Cooper Cameron Corporation
Cooper-Bessemer
Reciprocating Products Division
150 Lincoln Avenue
Grove City, PA 16127-1898
412 458-8000

Our Ref: QCG-10236

In accordance with the requirements of the Nuclear Regulatory Commission Title 10, Chapter 1, Code of Federal Regulations, Part 21, Cooper-Bessemer Reciprocating Products Division, a division of Cooper Cameron Corporation, hereby notifies the Commission of a potential design defect of the KSV emergency diesel generator (EDG) system.

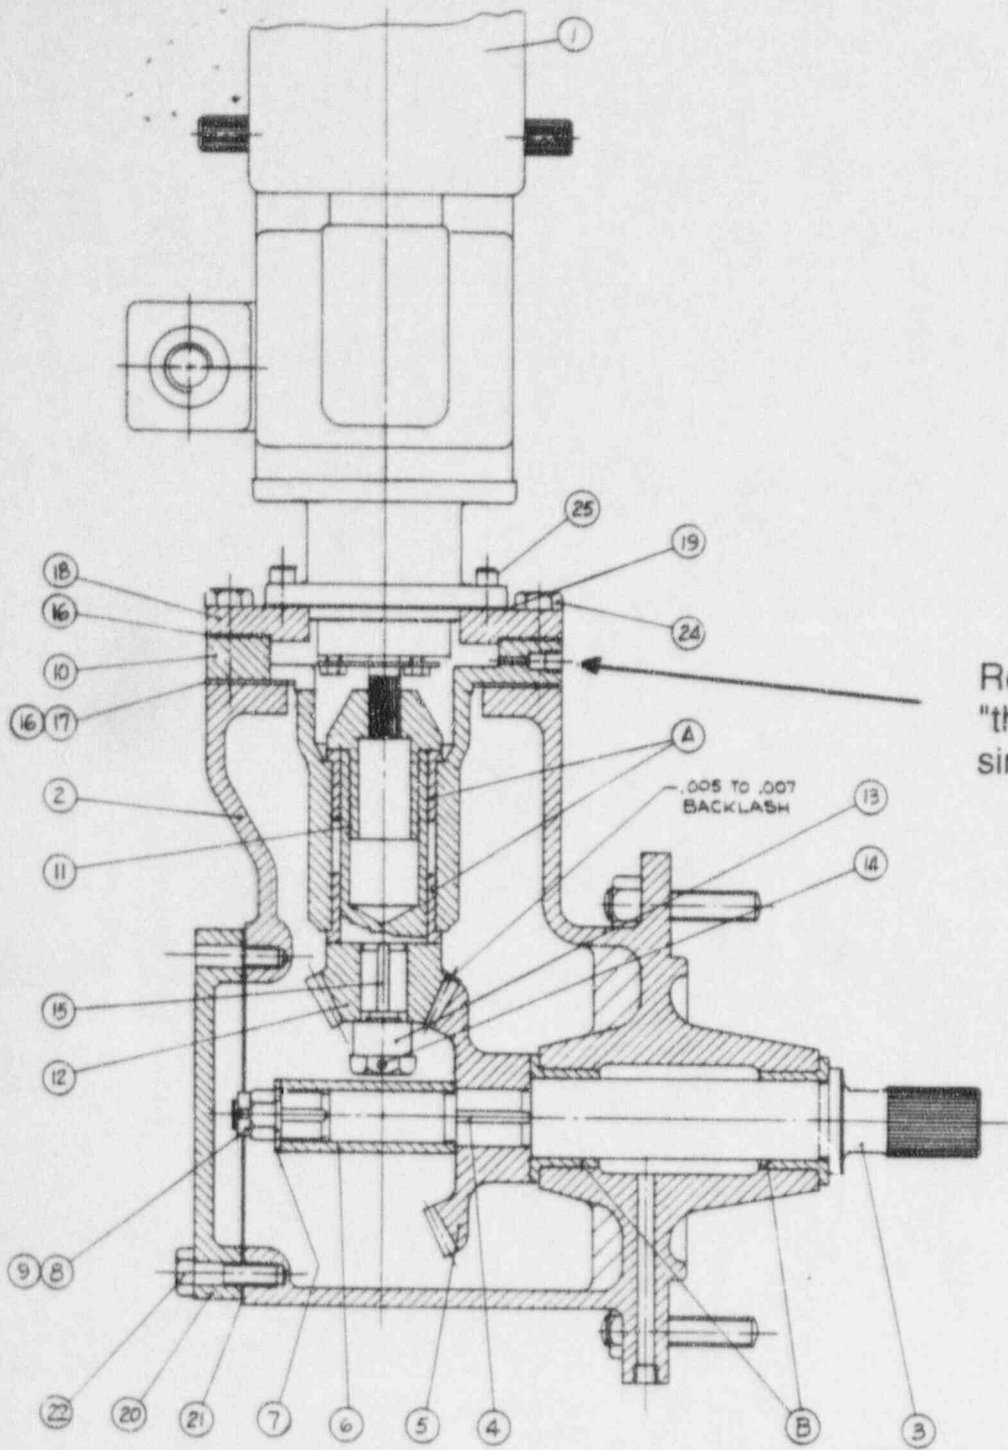
On November 6, 1995, Braidwood Station reported that during maintenance activities excessive wear and rust was noted in the upper portion of the governor drive assembly (Assembly No. KSV-17-6). On November 7, 1995, Braidwood reported that the oil inlet hole in the top flange of the bearing retainer did not appear to extend through to the inside of the flange. The report indicated this was due to a sleeve repair of the bore blocking the oil hole.

Lack of oil in this area could result in failure of this assembly resulting in EDG inoperability. Due to the potential of this defect and the ease of verification, it is recommended that all utilities verify an open oil passage in this assembly (see attachment).

Remove oil line and verify
"through" hole using wire or
similar object.
